SERVICE BULLETIN 33

SUBJECT: GLASAIR III ENGINE MOUNT AND FIREWALL TEMPLATE.

APPLICATION: Glasair III kits; S/N 3015 thru 3026

FIGURE (1)

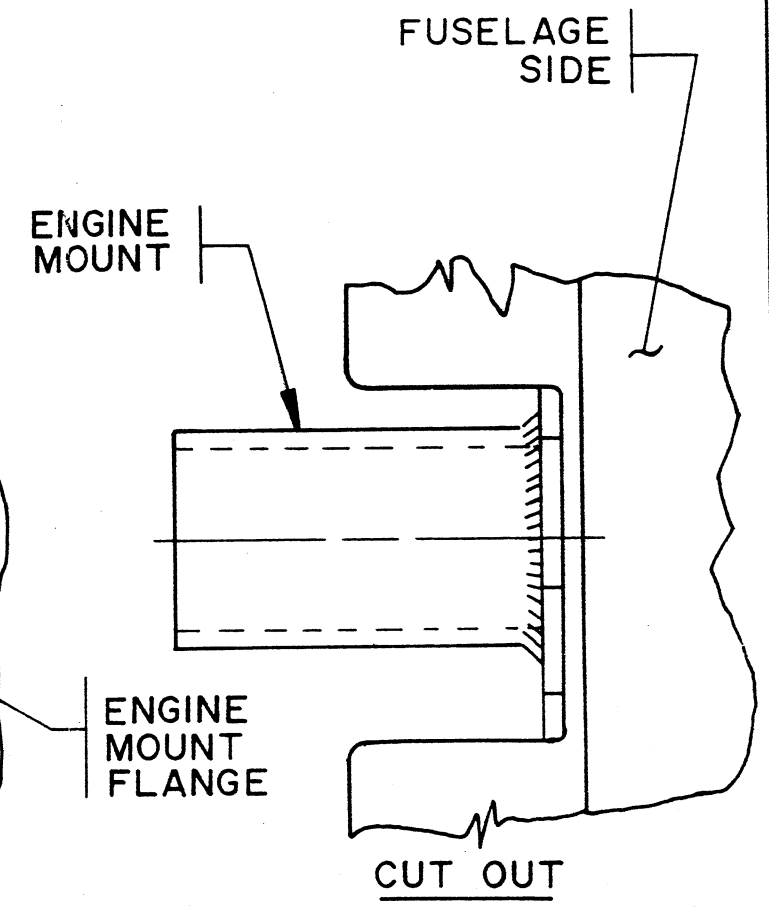
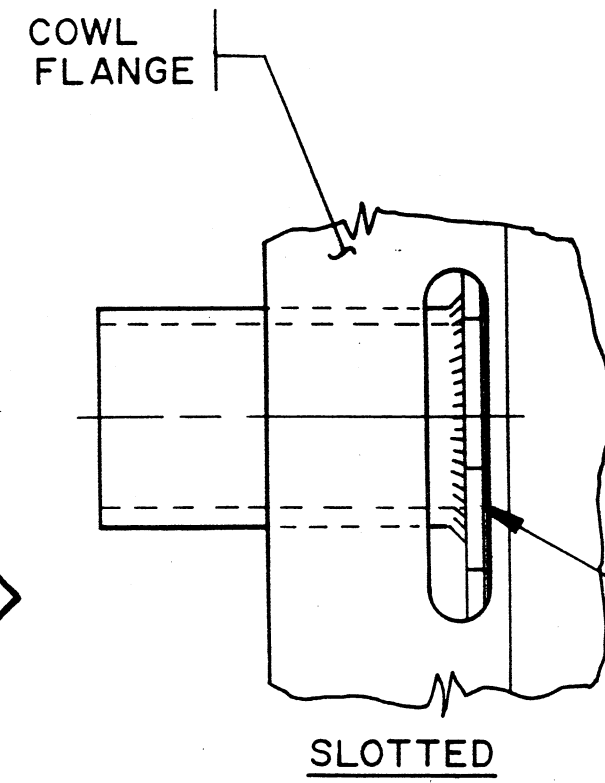
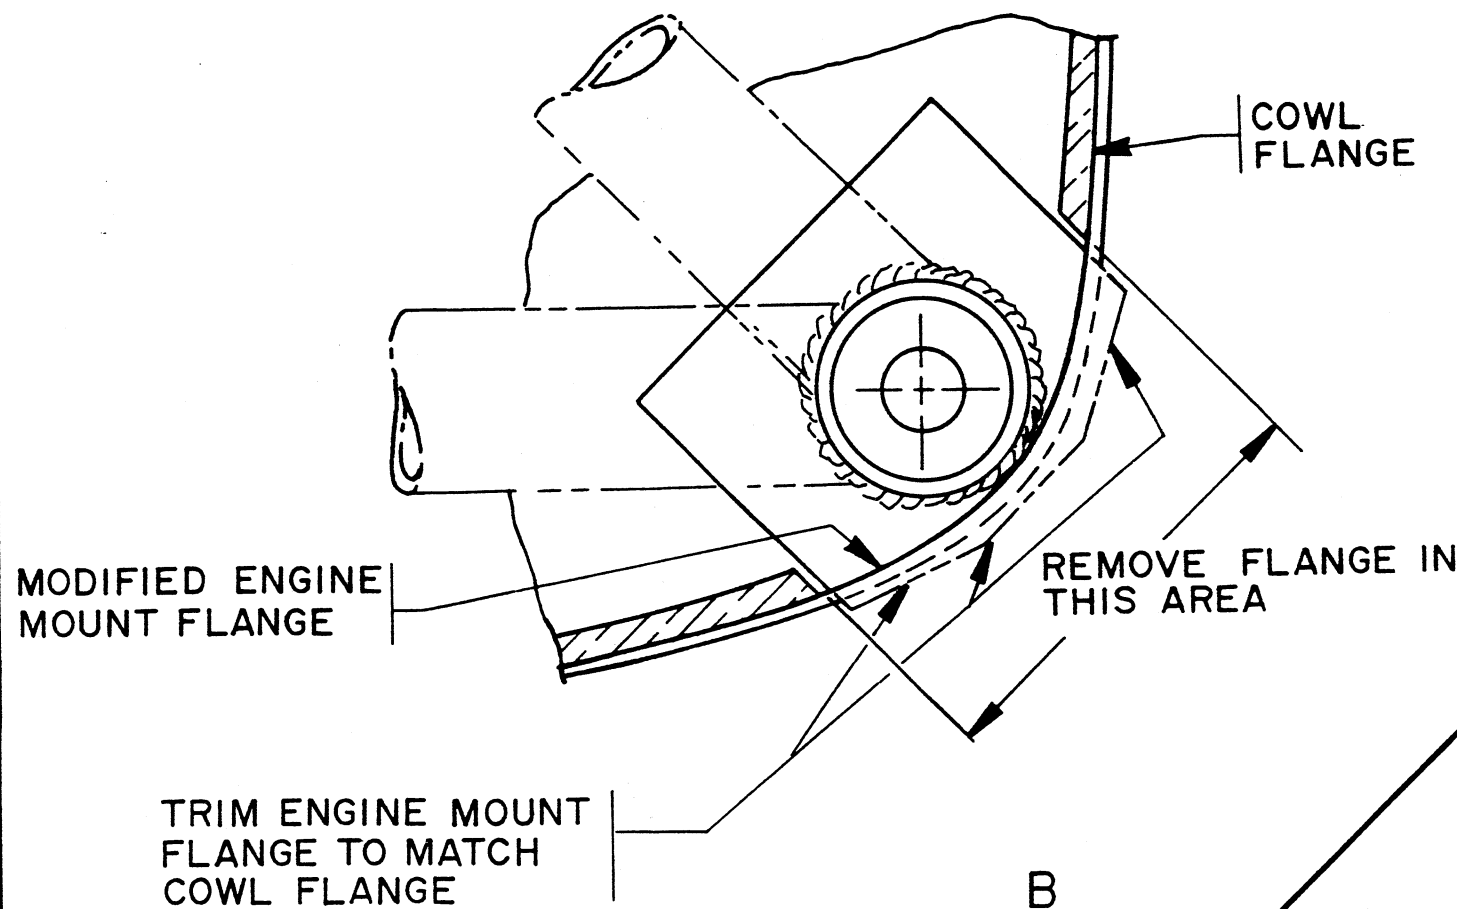
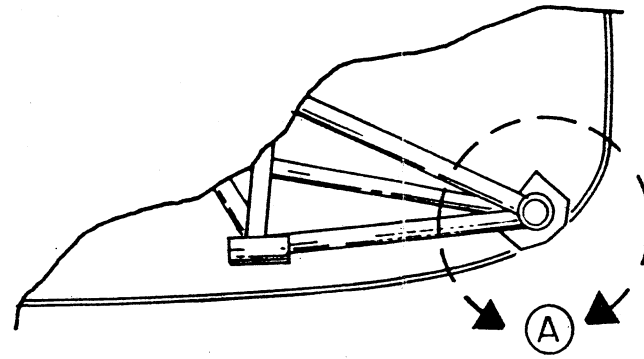
On the Revision A style engine mounts, the lower outboard engine mount points will require grinding of the base plates. The fiberglass cowl flanges must be locally trimmed back flush with the firewall or slotted to provide clearance for the baseplate. See FIGURE (1).

In addition a slight interference may exist between the lower corner engine mount tube and the lower cowling. The lower cowling slopes upward from the firewall and the engine mount tube extends straight forward. These tubes may also be ground for proper clearance when the lower cowling is fit to the aircraft.

NOTE: Grinding the base plates and trimming or slotting the fiberglass flanges are both structurally permissible and will not have any cosmetic effect pm the finished product.
